**BZA 17-72**  
 PLOT PLAN  
 for  
**BEVILL'S FIRESTONE**  
 HOOVER & CENTRAL, WICHITA, KANSAS.  
 R. S. DELAMATER  
 CONSULTING ENGINEER  
 WICHITA, KANSAS  
 DATE: JUNE 2, 1972  
 SCALE: 1" = 20'  
 207-B-101

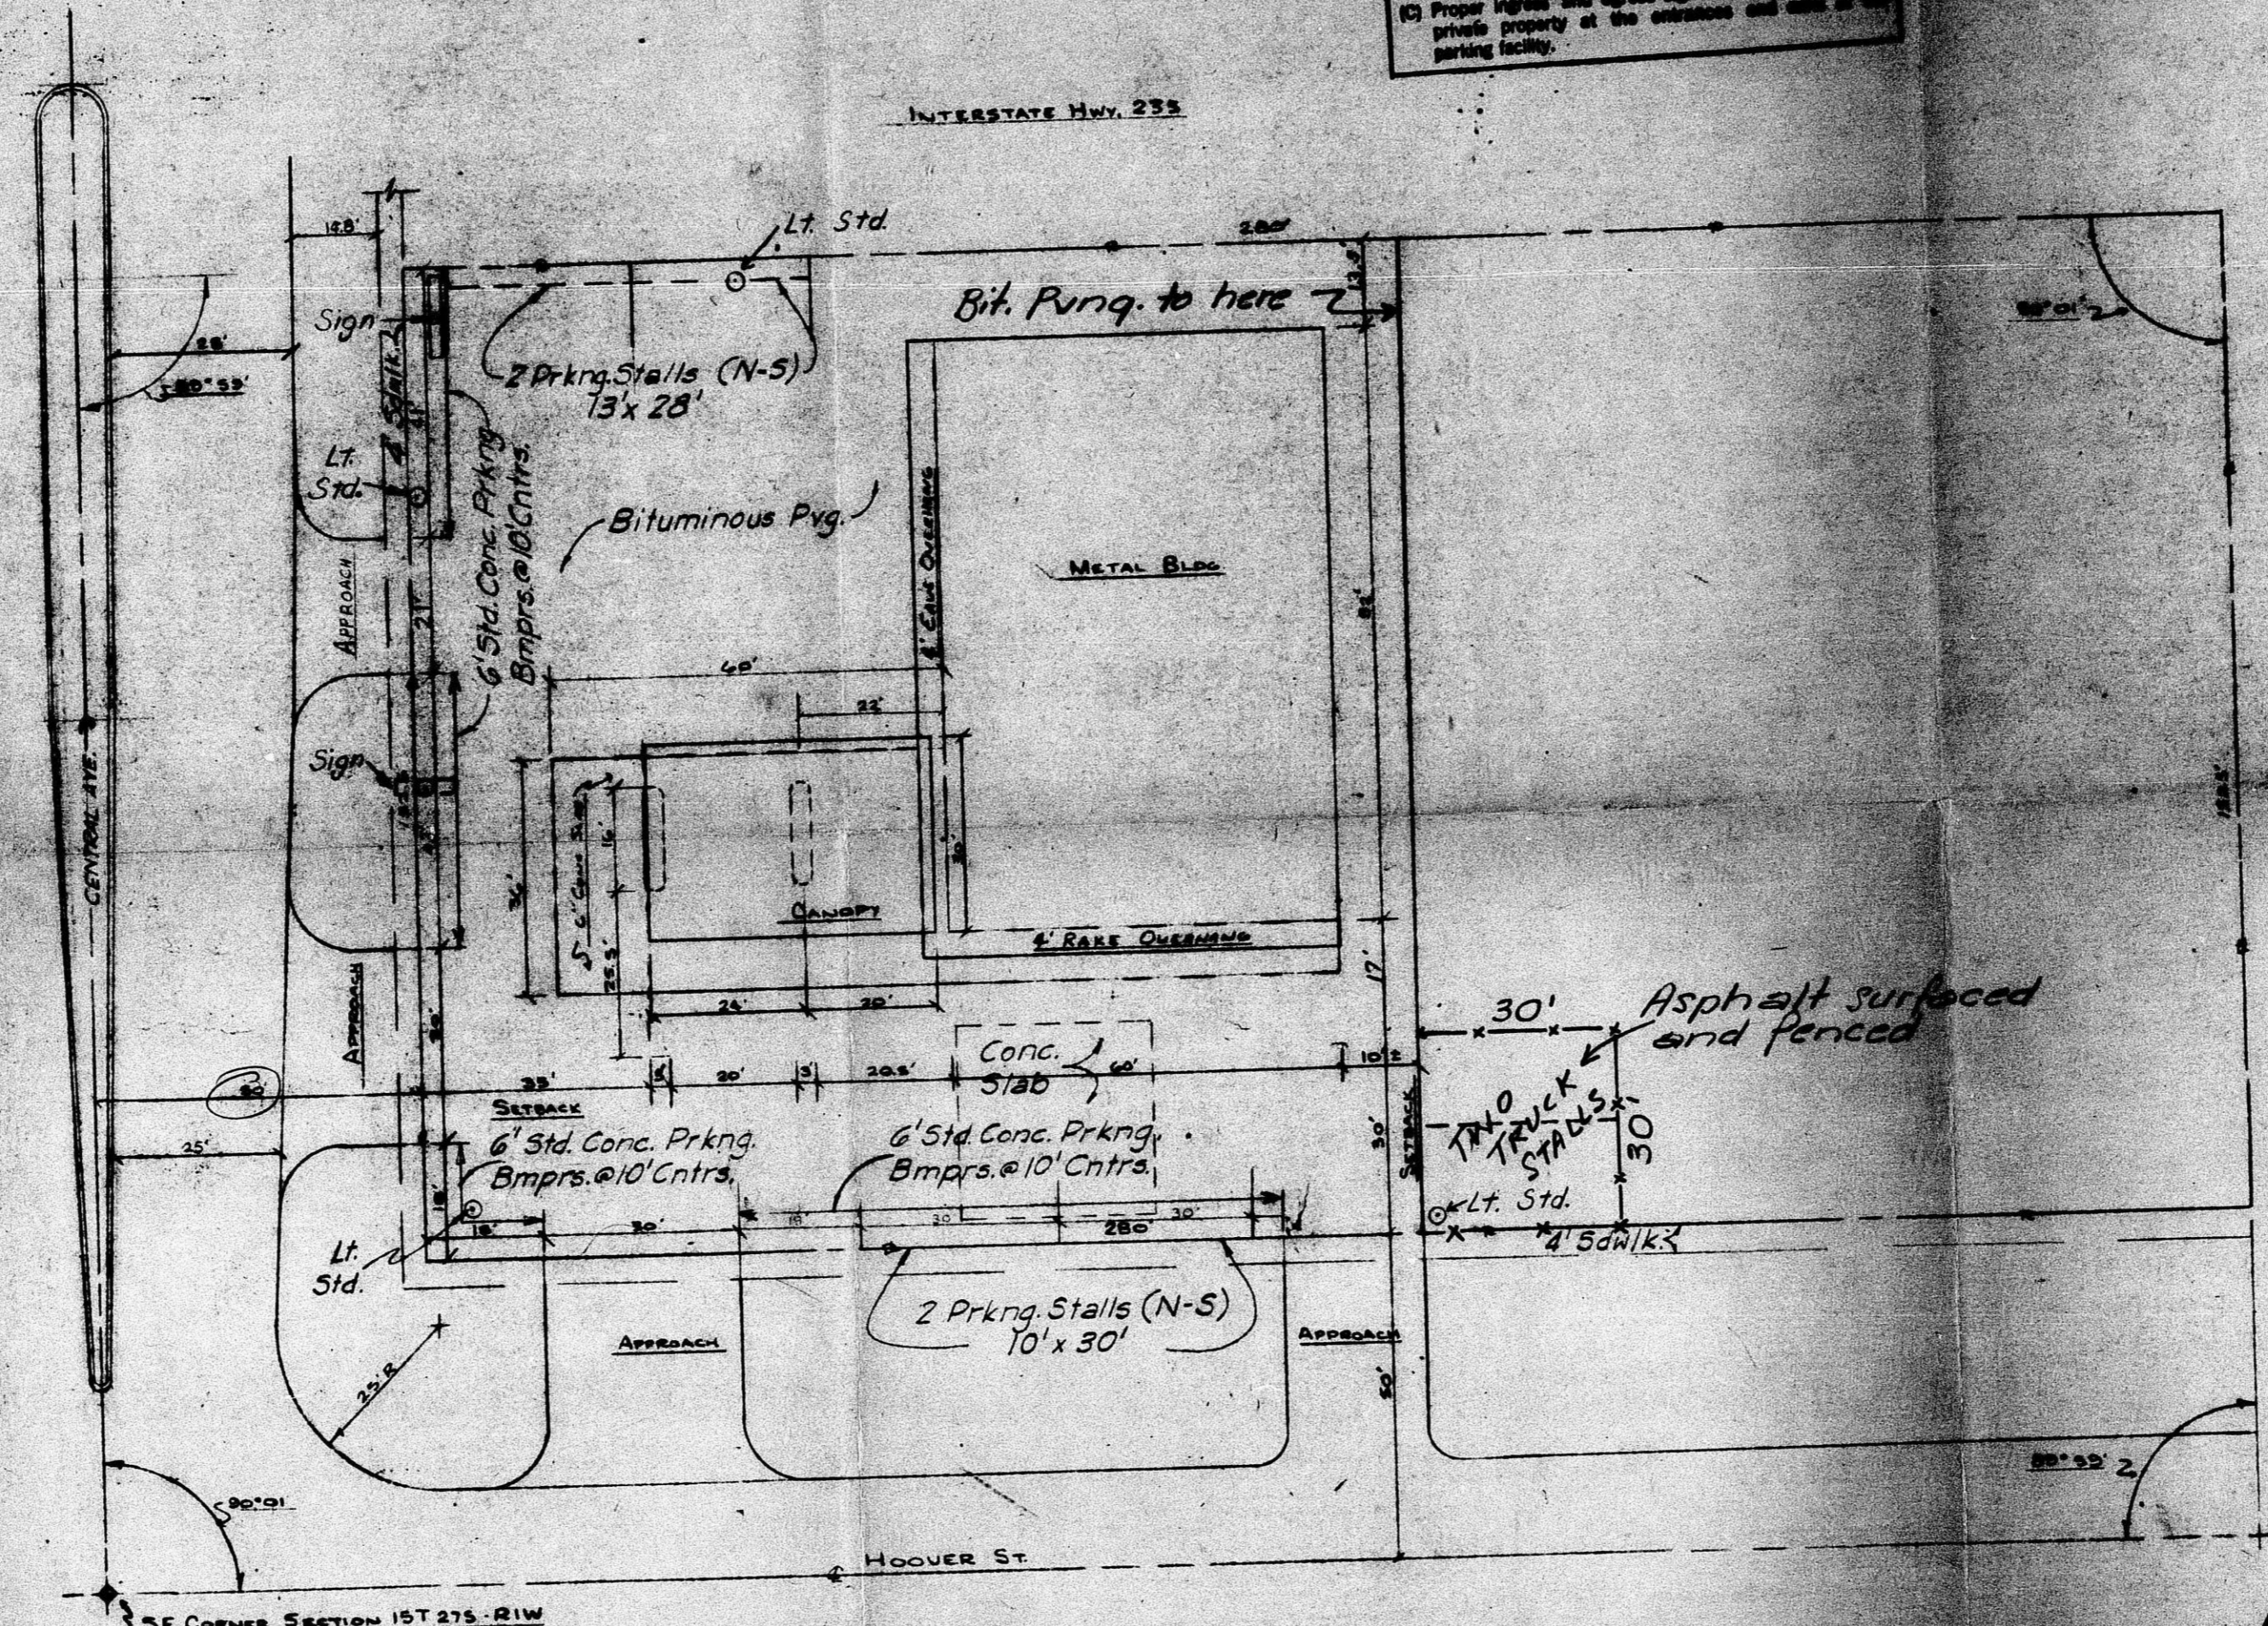
TRAFFIC ENGINEERING DIVISION APPROVAL  
 Date: 7/11/72  
 (1) Parking bays shall be marked at all corners and are adjacent to public property the lot boundary shall be marked with property lines and have a minimum width of 6 feet and a minimum cross section of 4' x 4'.  
 (2) All lines shall be painted and 4" or greater in width.  
 (3) Proper ingress and egress signs shall be installed on private property at the entrance and exit of the parking facility.
